NOTICE OF ADDENDUM
ADDENDUM NO. 2
CONTRACT NO. 8292

HAMMERSLEY AVENUE ASSESSMENT DISTRICT – 2018

HAMMERSLEY AVENUE ASSESSMENT DISTRICT - 2019

CONTRACT NO. 8292

TYPICAL SECTIONS
HAMMERSLEY AVE
STANDISH CT
ALDEN DR
CITY OF MADISON

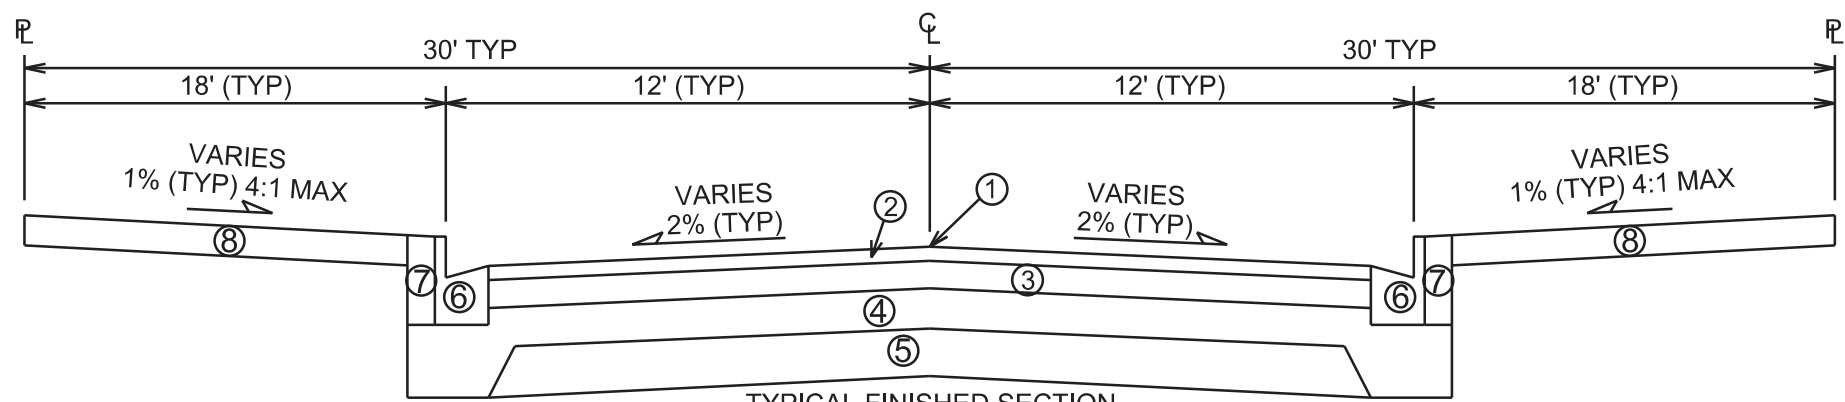
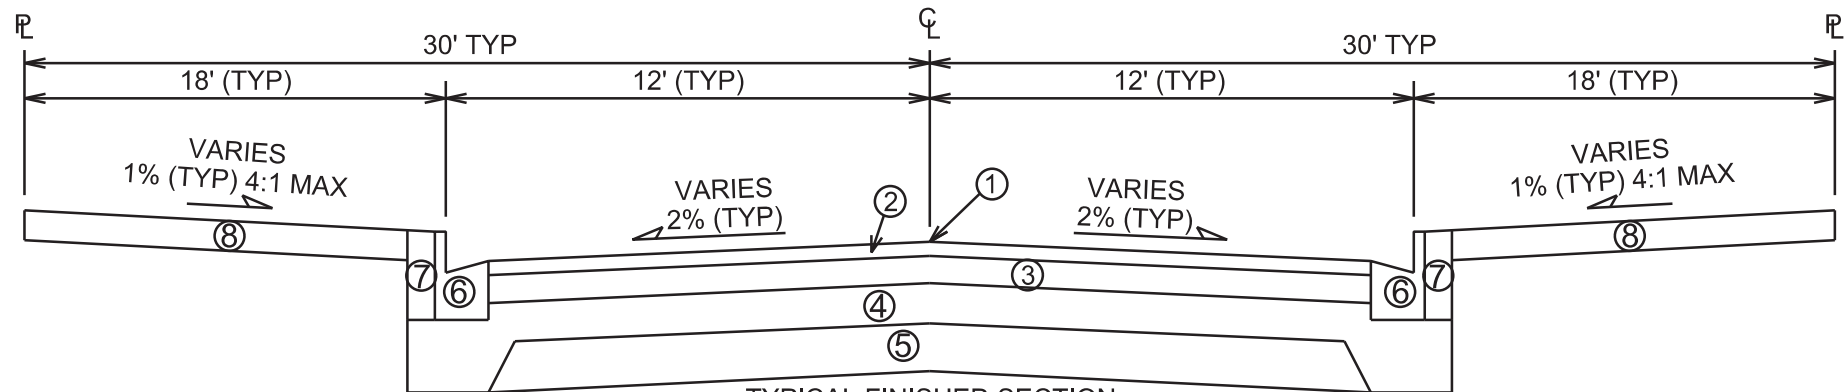
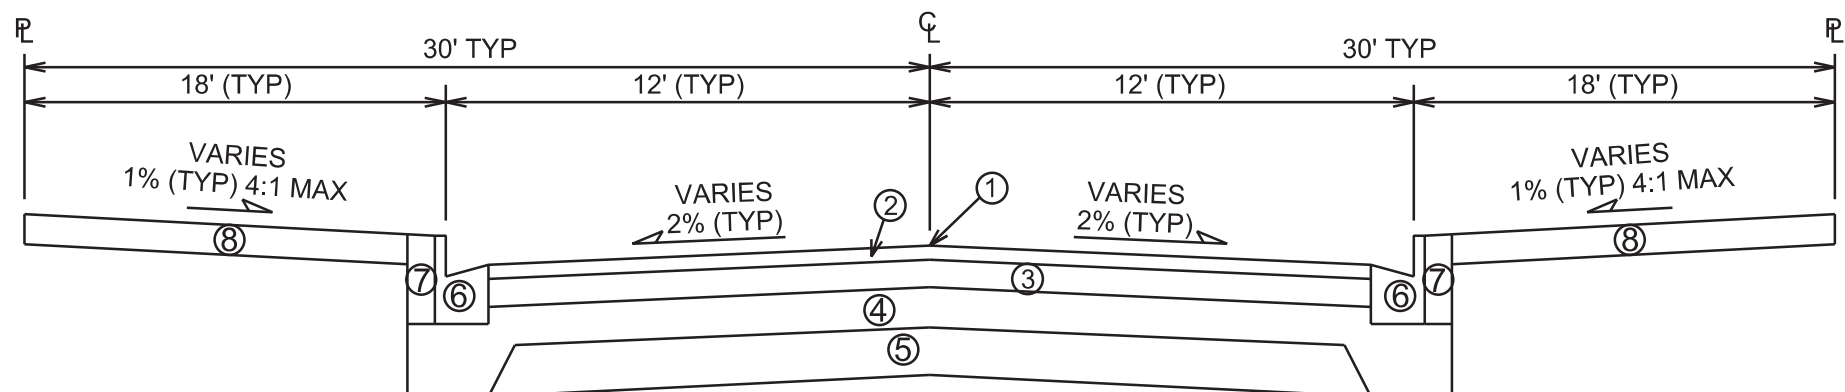
D-1: Revised the upper and lower pavement type to 4 LT.

REVISION 1/4/19-AJZ
-change upper & lower
pavement type to 4 LT

- ① POINT REFERRED TO ON PROFILE
- ② 1 3/4" HMA UPPER LAYER, 4 LT 58-28 S
- ③ 1 3/4" HMA LOWER LAYER, 4 LT 58-28 S
- ④ 6" GRADATION 2 CRUSHED STONE
- ⑤ 6" GRADATION 1 CRUSHED STONE
- ⑥ TYPE 'A' OR 'X' CONCRETE CURB & GUTTER
- ⑦ FILL, INCIDENTAL
- ⑧ 6" TOPSOIL, TERRACE SEED AND EROSION MAT

UTILITY PLAN AND PROFILE
STORM EASEMENT CITY OF MADISON

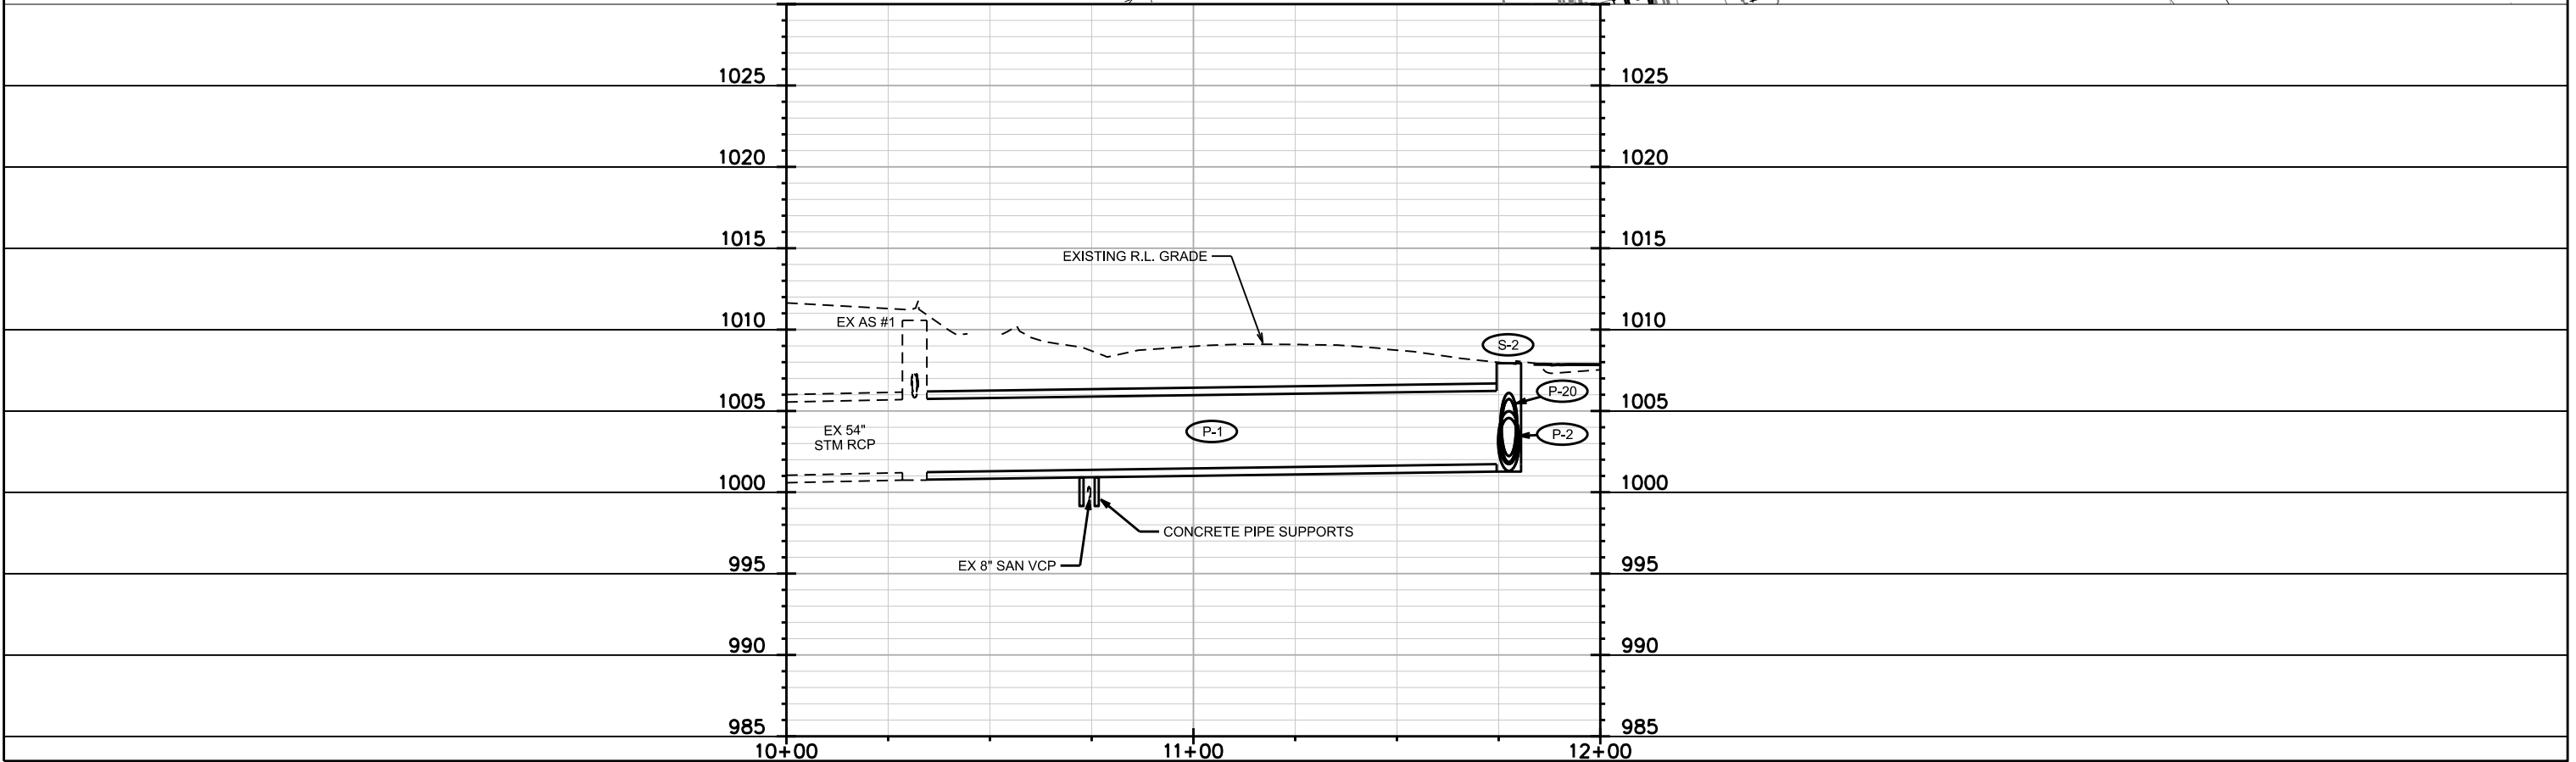
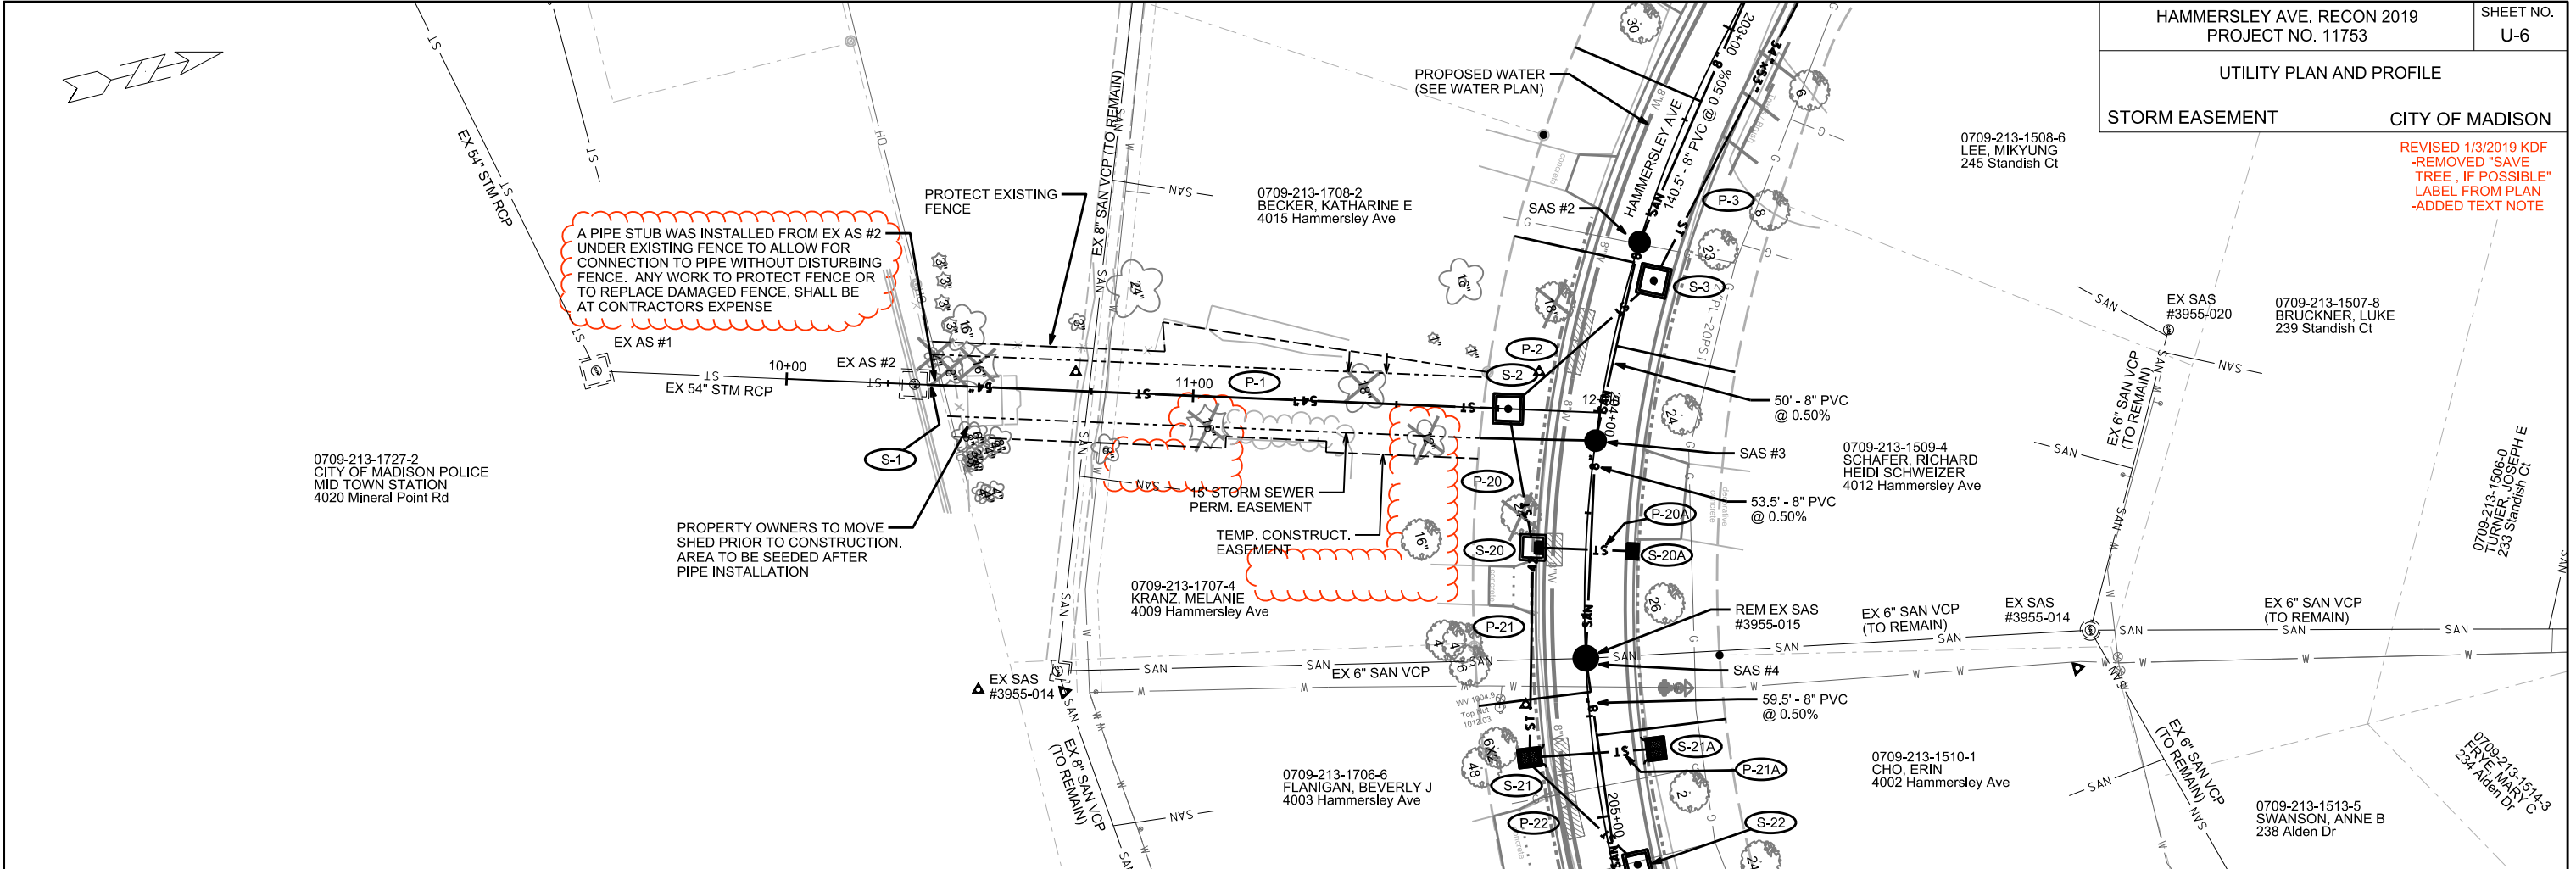
U-6: Removed call off “save tree, if possible”. Tree needs to be removed and added text note.

REVISED 1/3/2019 KDF
-REMOVED "SAVE TREE, IF POSSIBLE" LABEL FROM PLAN
-ADDED TEXT NOTE

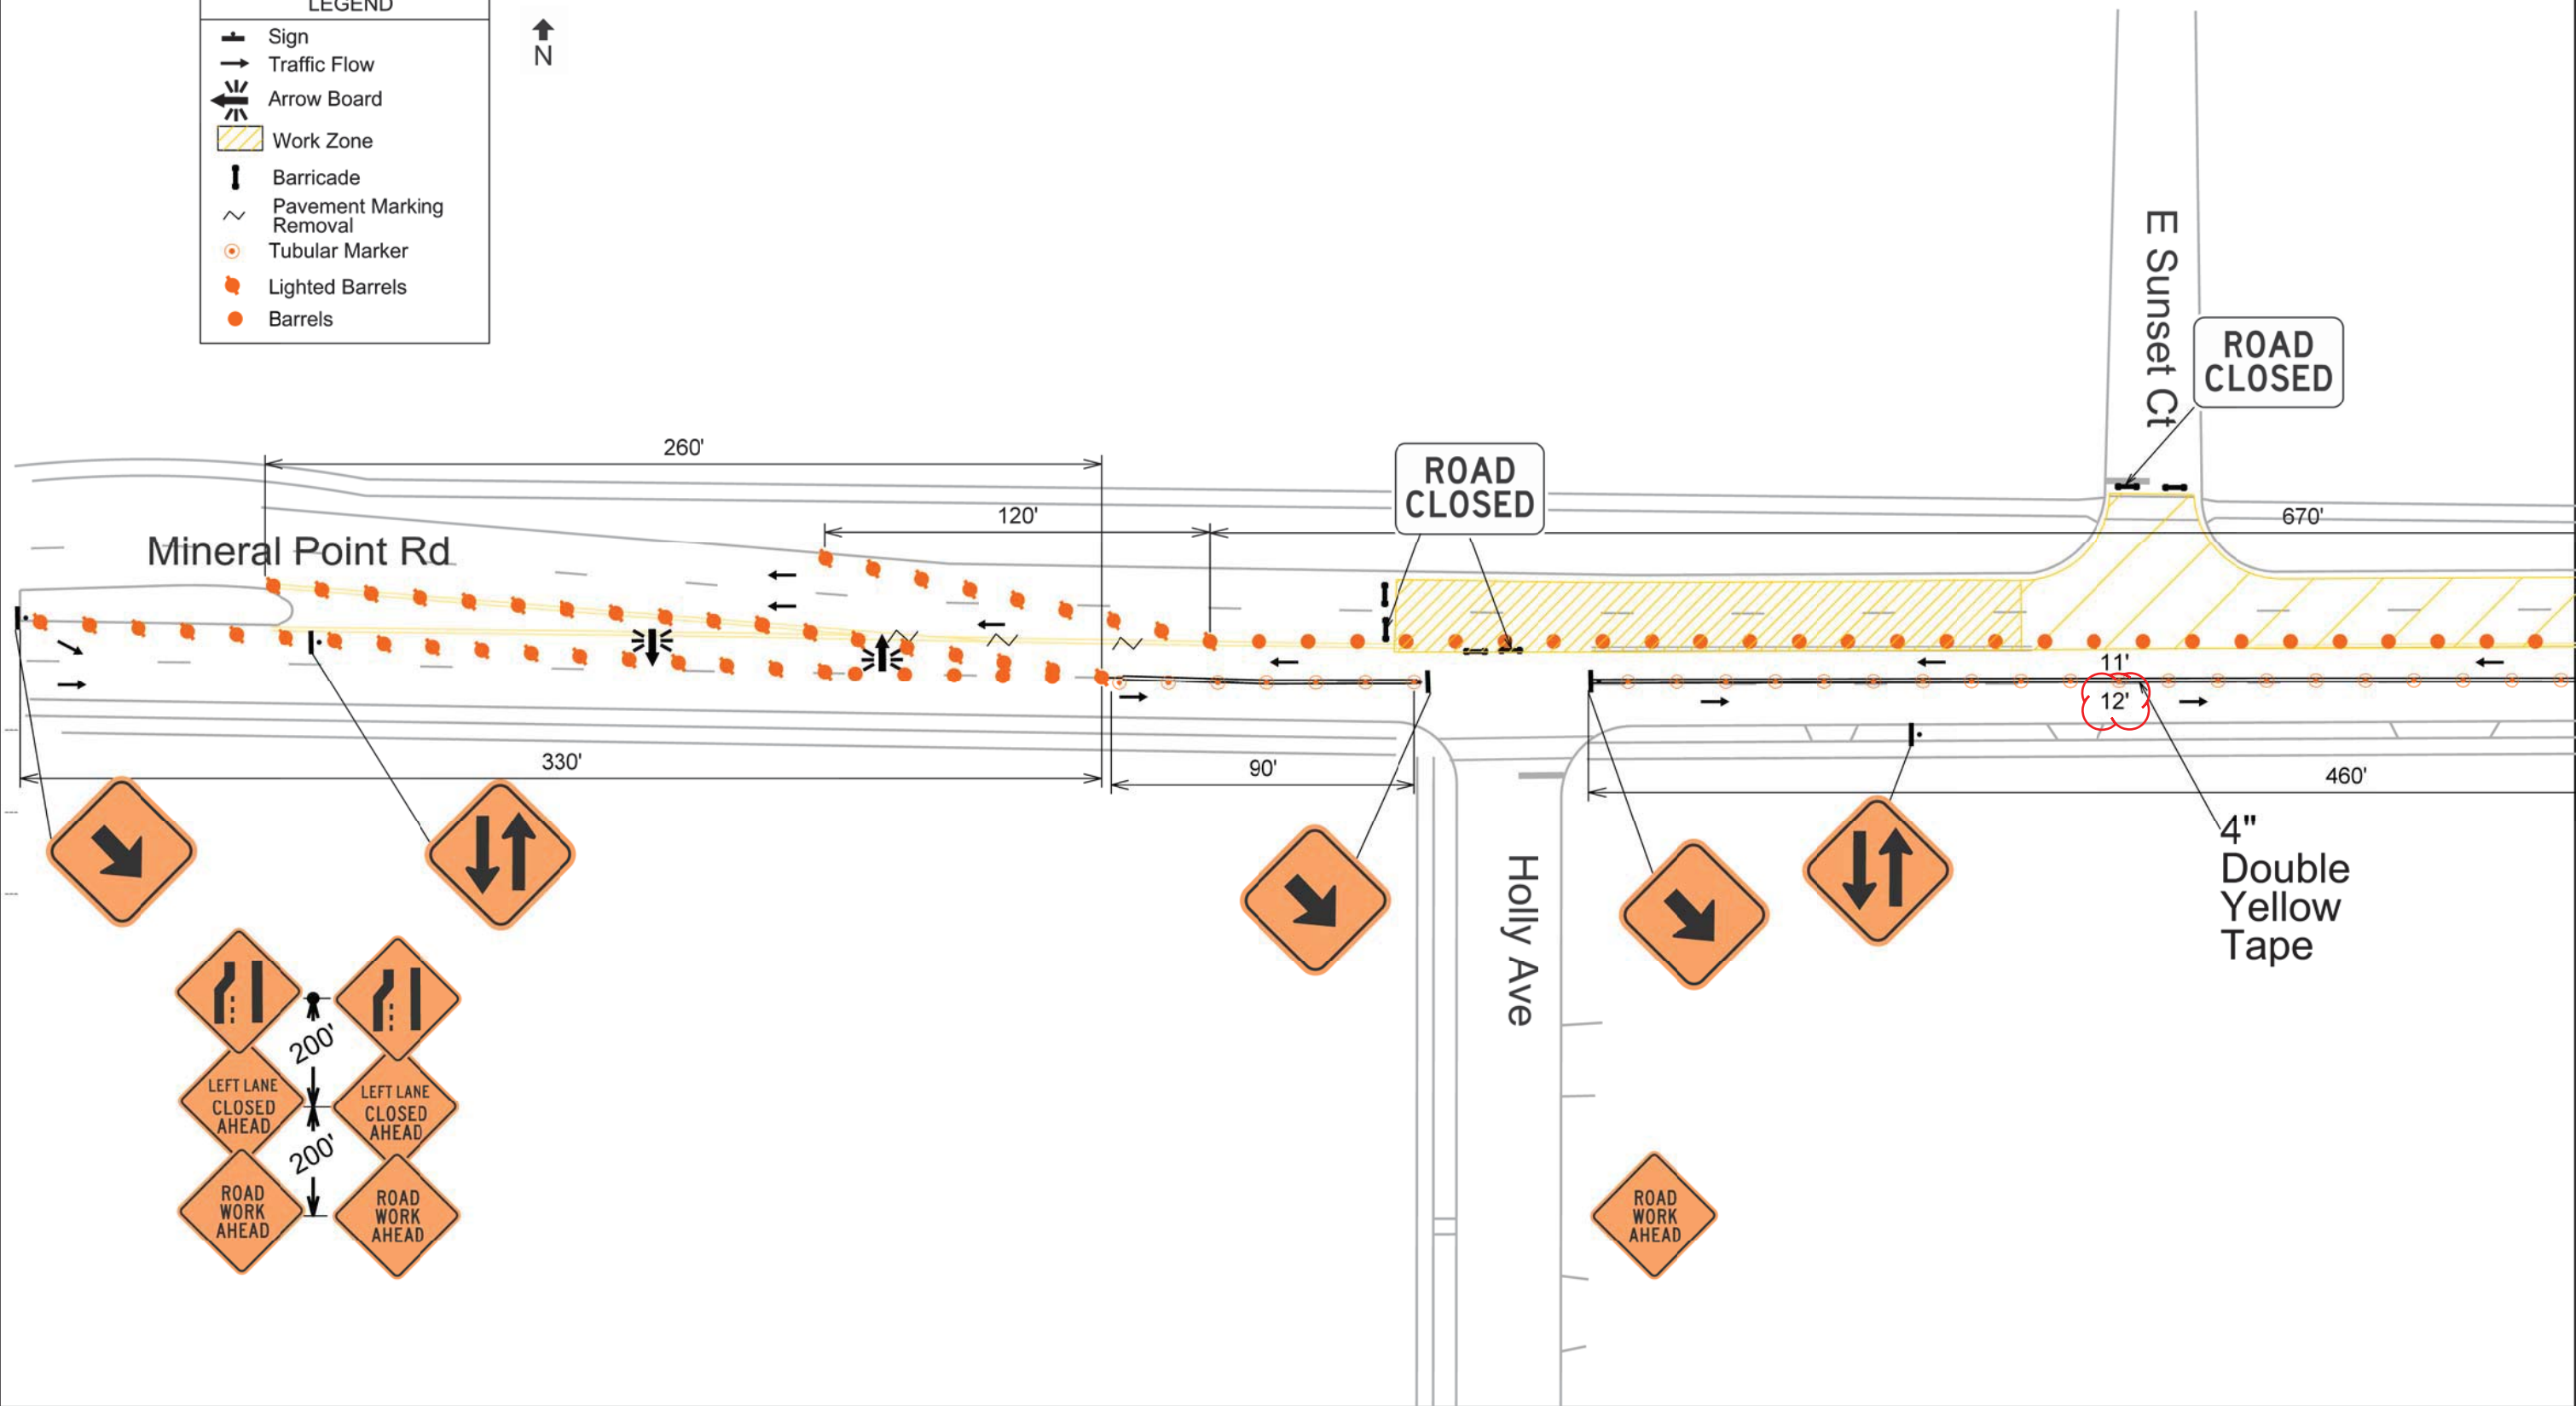
TC-1 & TC-2: Changed outside lane width to 12 feet.

REVISION 1/4/19 AH
-changed outside lane width to 12 feet.
